DA RE-ISSUE IMPLEMENTING ACTIONS TO COMPLY  
WITH COUNCIL RFI'S / DEAP GUIDANCE (15.10.20)

Project  
Project Name  
12-14 BIRNIE AVENUE  
LIDCOMBE

REVISION SCHEDULE:  
1) BUILDING 8 HAS BEEN REDUCED IN HEIGHT BY ONE STOREY (TO COMPLY WITH COUNCIL GFA REQUIREMENTS)  
2) THE PODIUM OF BUILDING A HAS BEEN REDUCED IN LENGTH (TO COMPLY WITH COUNCIL GFA REQUIREMENTS)

SECTION A

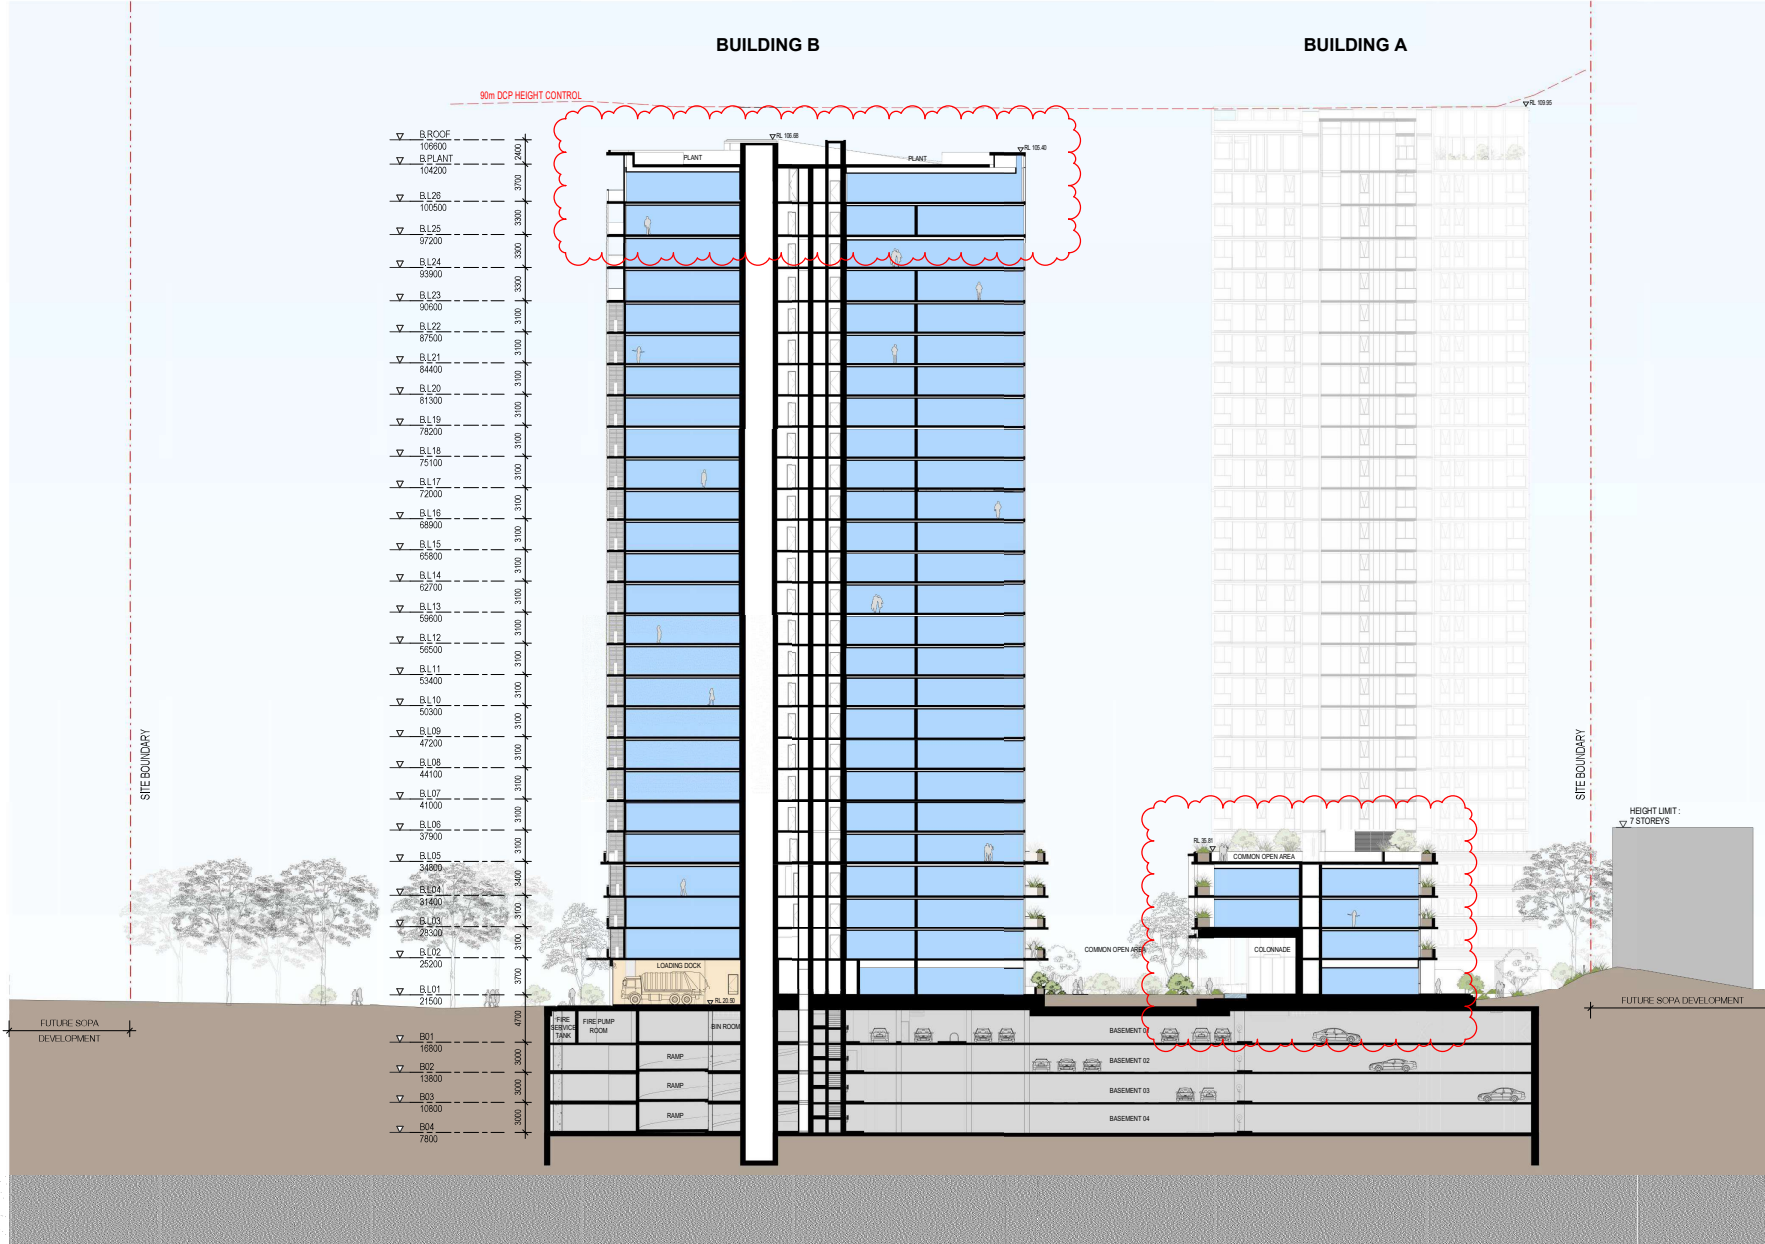
- REVISION SCHEDULE:**
- 1) BUILDING B HAS BEEN REDUCED IN HEIGHT BY ONE STOREY (TO COMPLY WITH COUNCIL GFA REQUIREMENTS)
  - 2) THE PODIUM OF BUILDING A HAS BEEN REDUCED IN LENGTH (TO COMPLY WITH COUNCIL GFA REQUIREMENTS)

- 3) INTERIOR LAYOUT OF THE BUILDING A PODIUM HAS BEEN UPDATED
  - 4) INTERIOR LAYOUT OF LEVELS 24/25/26/27 HAVE BEEN UPDATED (BUILDING A & B)
  - 5) THE FACADE HAS BEEN REGULARISED, REDUCING THE NUMBER OF WINDOW TYPES

- 6) THE SETBACK FROM THE EDWIN FLACK BOUNDARY TO BUILDING B HAS INCREASED, MEASURING 5M TO THE PODIUM & 6.5M TO THE TOWER
  - 7) THE BASEMENT SETBACK HAS BEEN INCREASED TO MEASURE 5M FROM THE EDWIN FLACK BOUNDARY

**1** SECTION - BUILDING A  
1 : 250

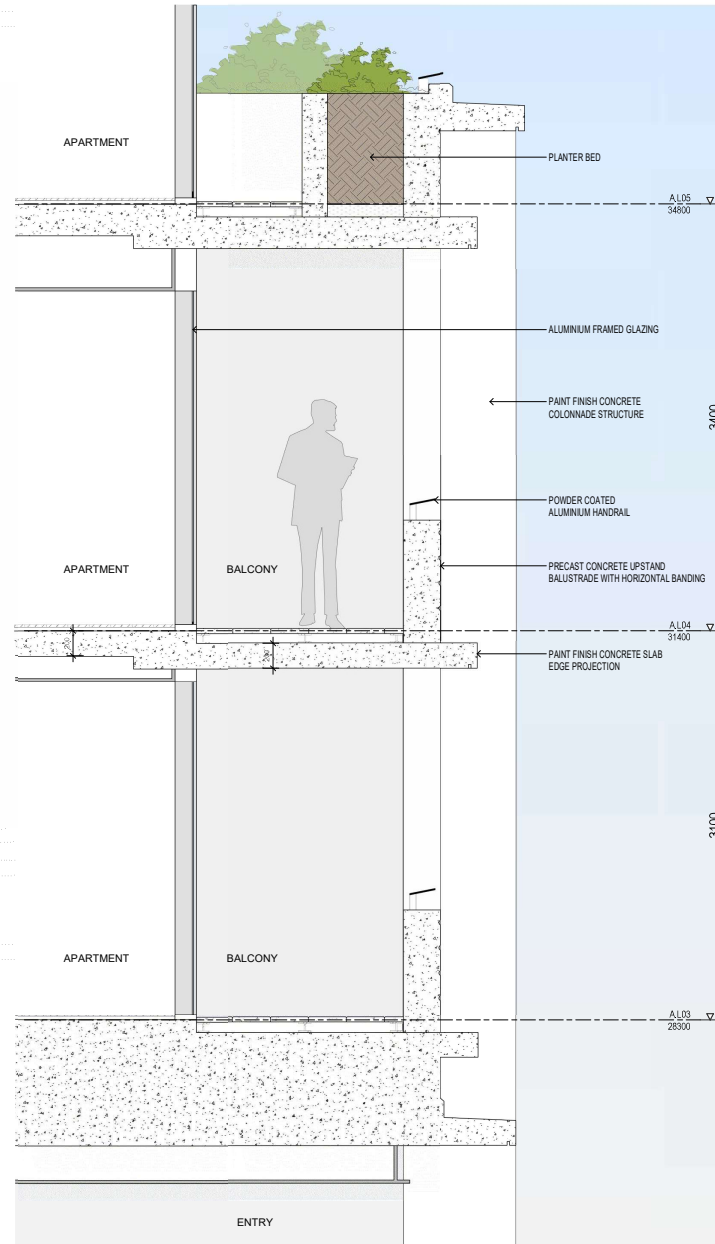
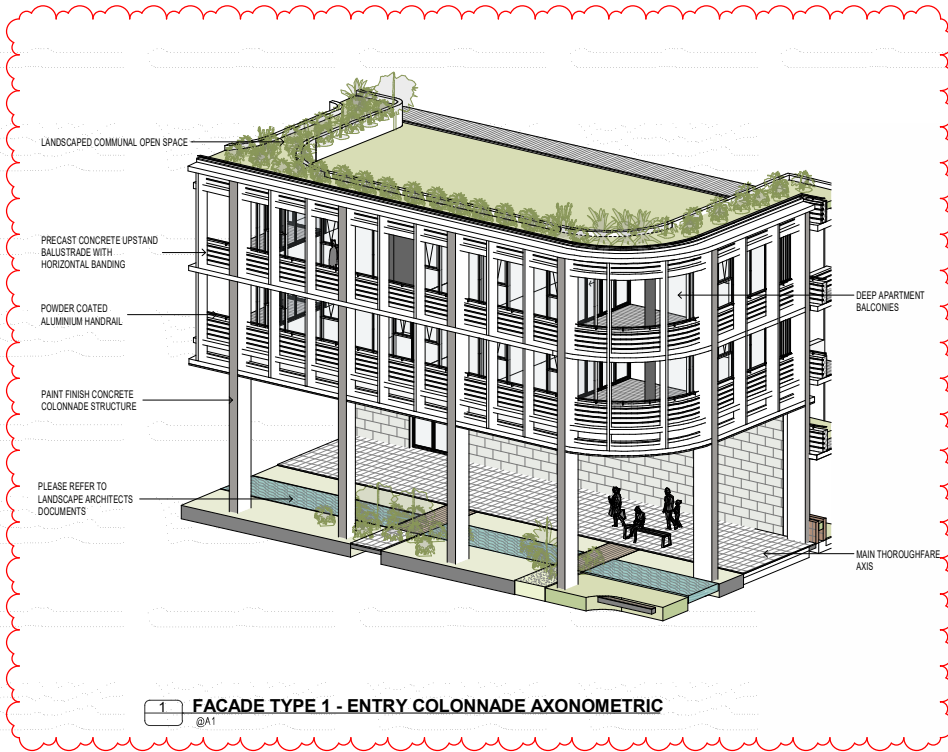
- REVISION SCHEDULE:
  - 1) BUILDING IS BEING REDUCED IN HEIGHT BY ONE STOREY (TO COMPLY WITH COUNCIL GFA REQUIREMENTS)
  - 2) THE PODIUM OF BUILDING A HAS BEEN REDUCED IN LENGTH (TO COMPLY WITH COUNCIL GFA REQUIREMENTS)

- 3) INTERIOR LAYOUT OF THE BUILDING A HAD BEEN UPDATED
  - 4) INTERIOR LAYOUT OF LEVELS 24/25/26/27 HAVE BEEN UPDATED (BUILDING A & B)
  - 5) THE FACADE HAS BEEN REGULARISED, REDUCING THE NUMBER OF WINDOW TYPES

- 6) THE SETBACK FROM THE EDWIN FLACK BOUNDARY TO THE EDWIN FLACK ROAD, MEASURING 5M TO THE PODIUM & 6.5M TO THE TOWER
  - 7) THE BASEMENT TOWER HAS BEEN INCREASED TO MEASURE 5M FROM THE EDWIN FLACK BOUNDARY
